# LAUREL LAKE VILLAS

## HUDSON, OHIO

**AHBR DESIGN REVIEW**  
**MAY 27TH, 2026**

# STAFF COMMENTS 2026

# CASCADE, VILLAS 8 & 9 – REVISED ELEVATIONS

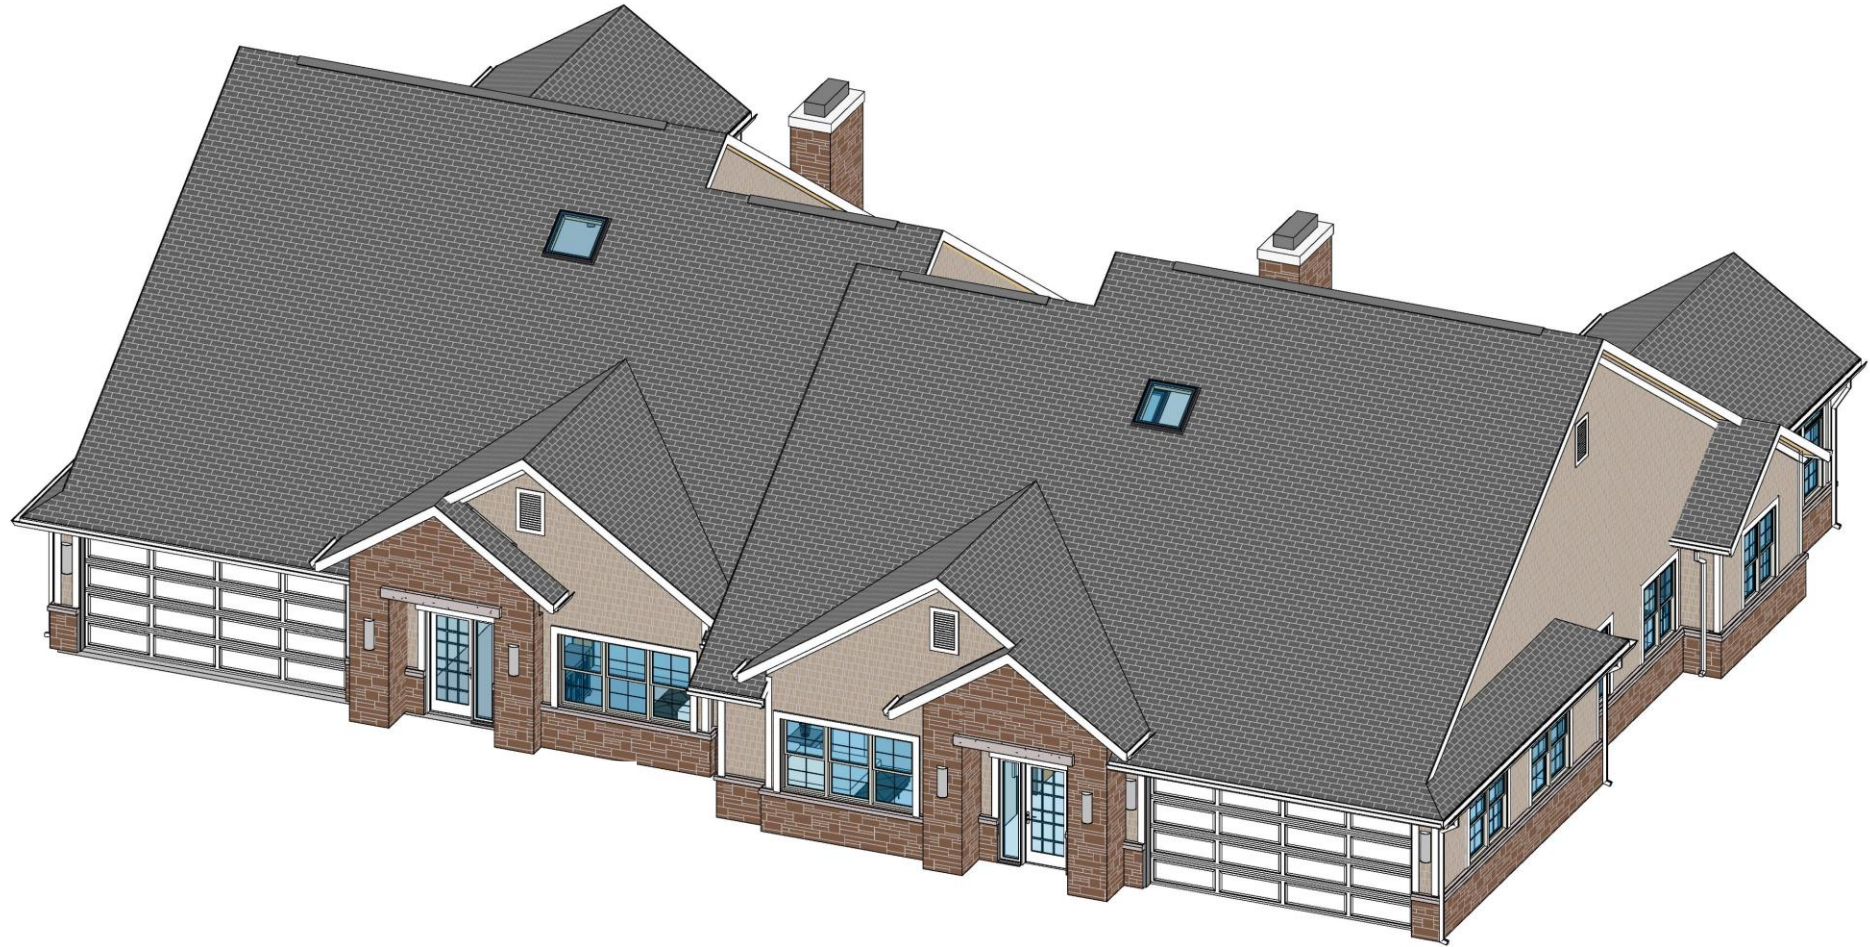
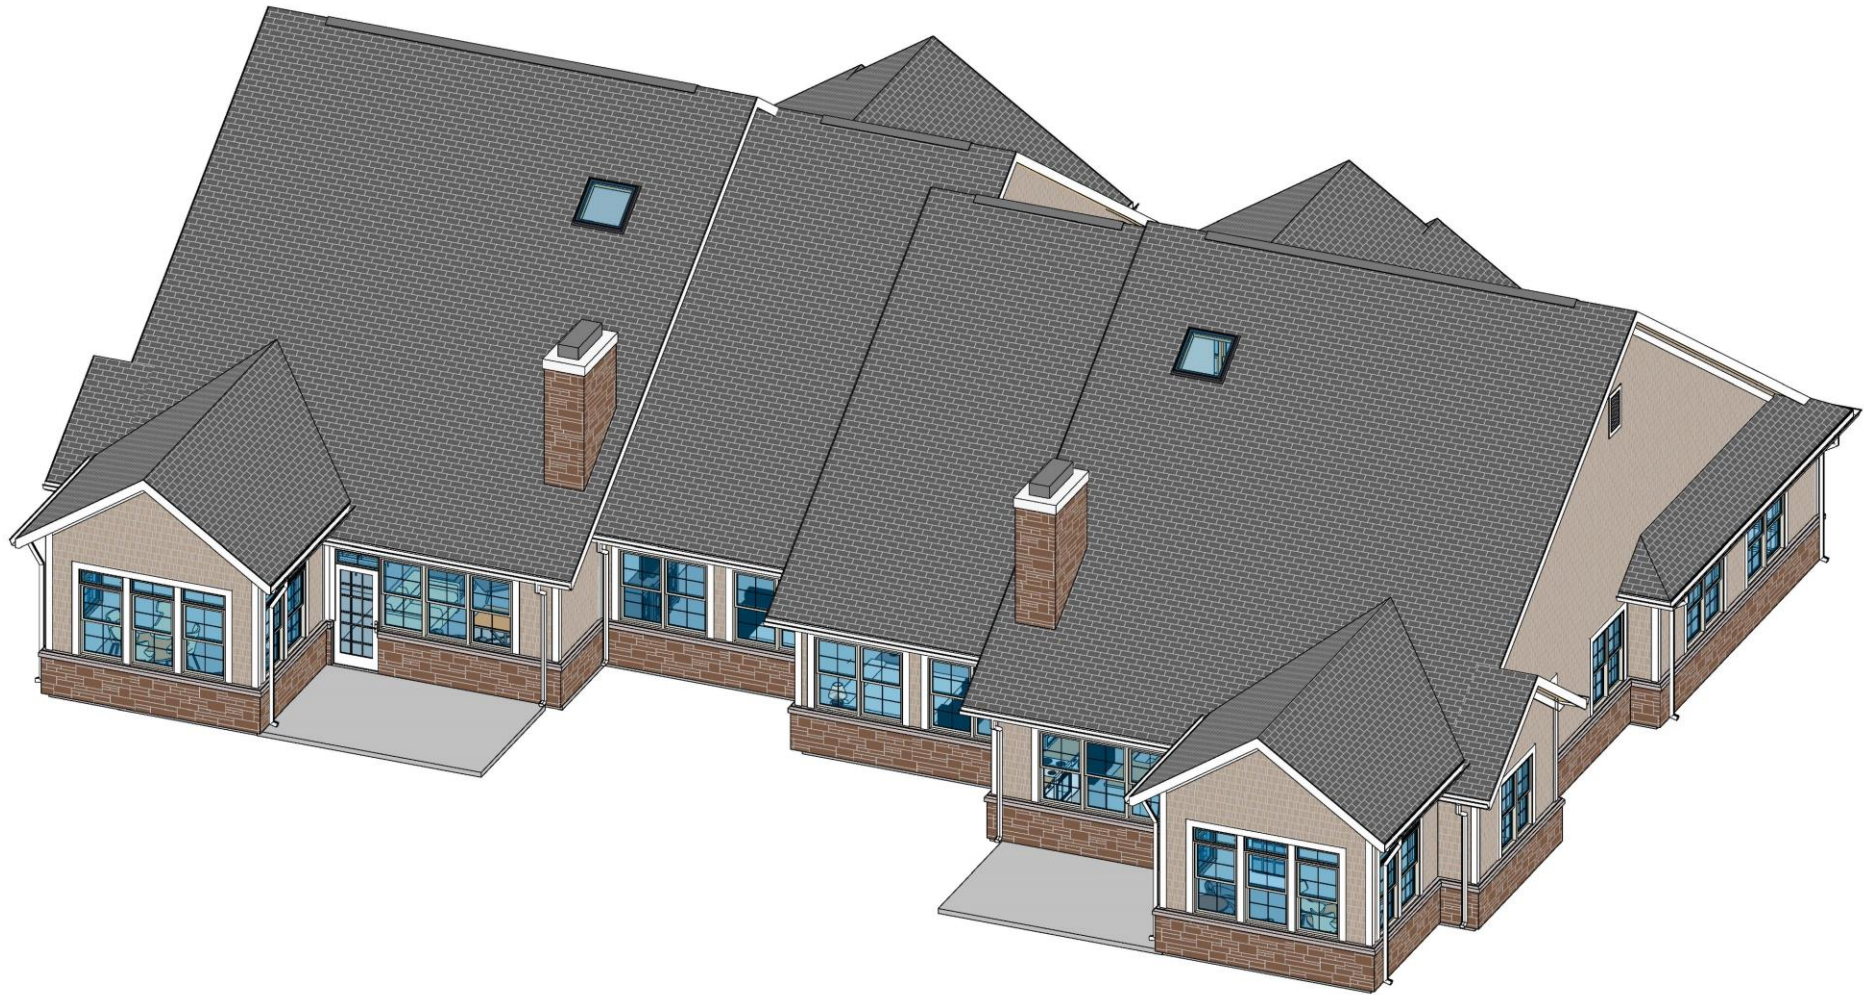
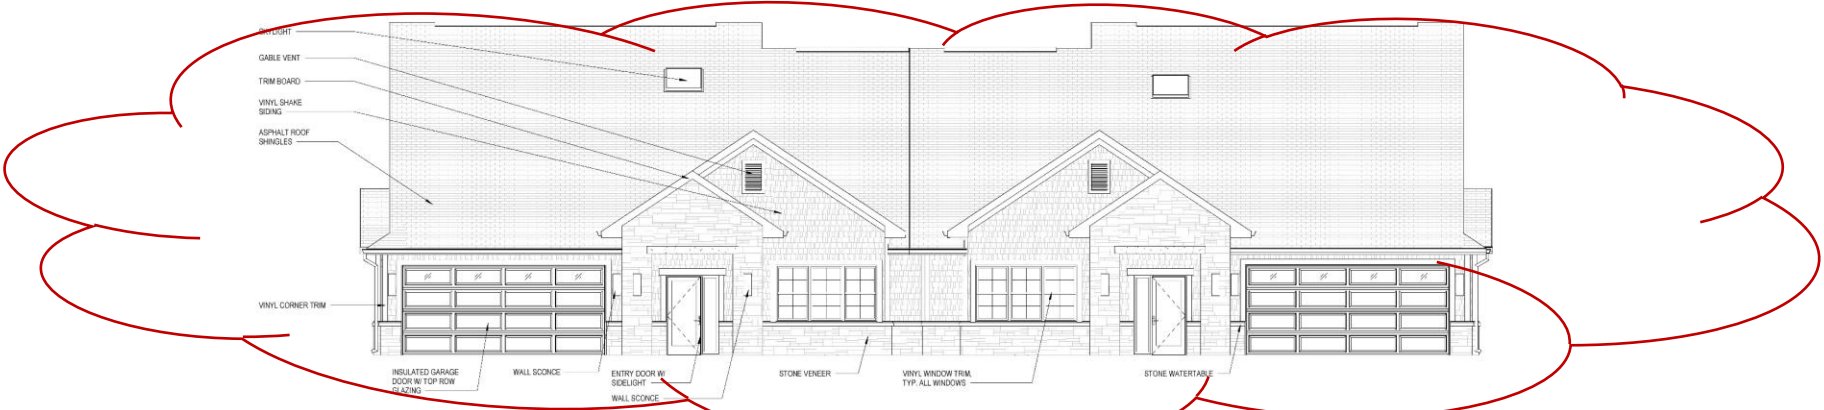
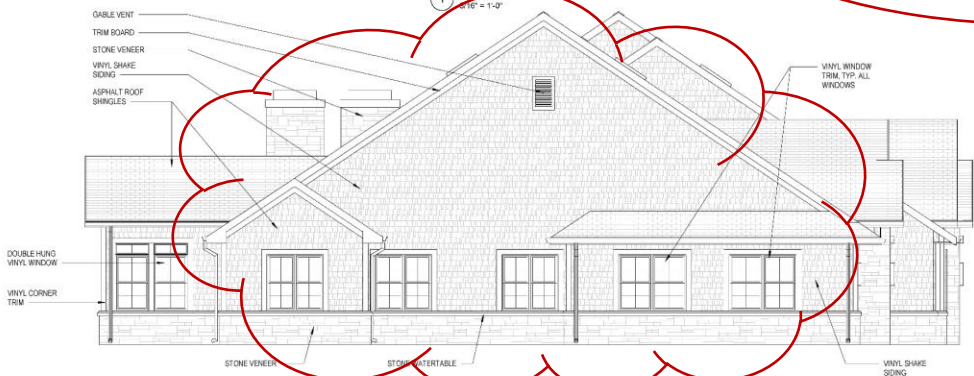
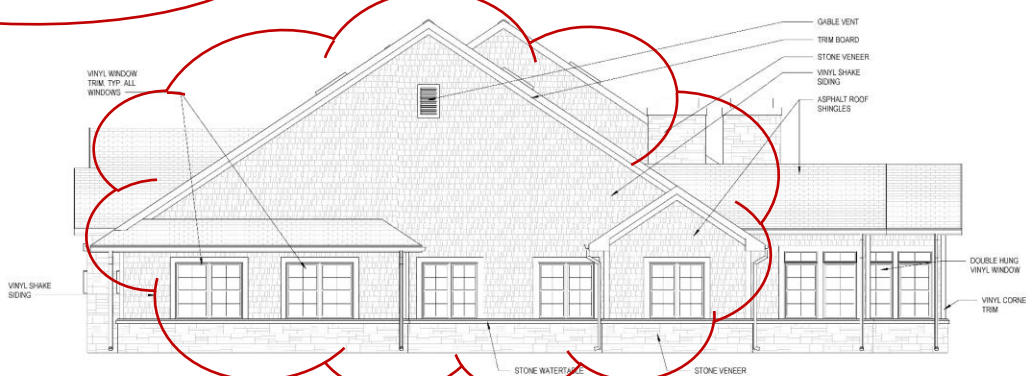
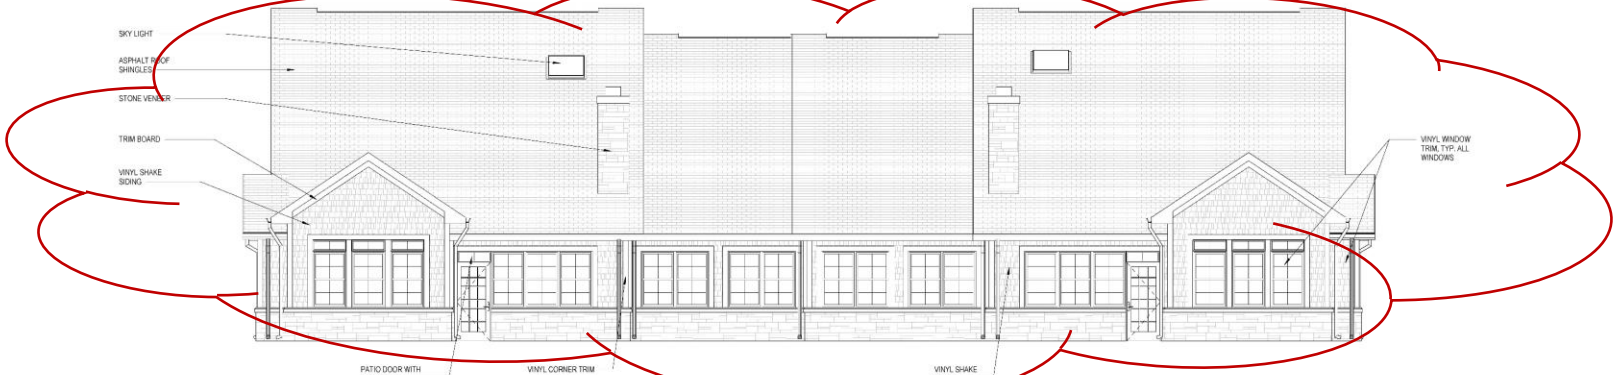
1. Section IV-3 (b)(3) – Forward facing garages.
2. Section IV-3 (b)(2) – Front Faceoff main body is 18” in front of all wings.
3. Section III-1(d)(5) – Fenestration every 12’
4. Section IV-3(c) – Roof to be same shape as main body.
5. Section III-1(g)(3) – Sunroom foundation material.
